**Economic Commission for Europe**

**Administrative Committee of the European Agreement  
Concerning the International Carriage of Dangerous  
Goods by Inland Waterways (ADN)**

**European Agreement concerning the International Carriage  
of Dangerous Goods by Inland Waterways (ADN)****Draft amendments to the Regulations annexed to ADN\***

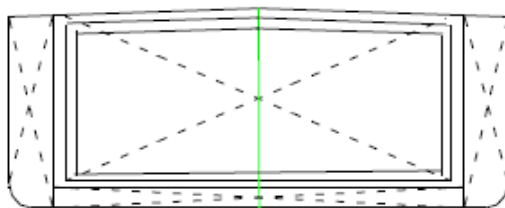
1.2.1 In the definition of *Classification of zones*, amend the fifth indent of the paragraph “**Zone 1** comprises” to read as follows:

“Every opening in zone 0 except the high velocity vent valves/safety valves of pressurized cargo tanks shall be surrounded by a cylindrical ring whose inner radius is that of the opening, the outer radius is equal to that of the opening plus 2.50 m and the height is 2.50 m above the deck and 1.50 m above the piping.

For openings with a diameter of less than 0.026 m (1”), the distance to the outer cofferdam bulkhead may be reduced to 0.50 m, provided it is ensured that such an opening is not opened to the atmosphere within this distance;”
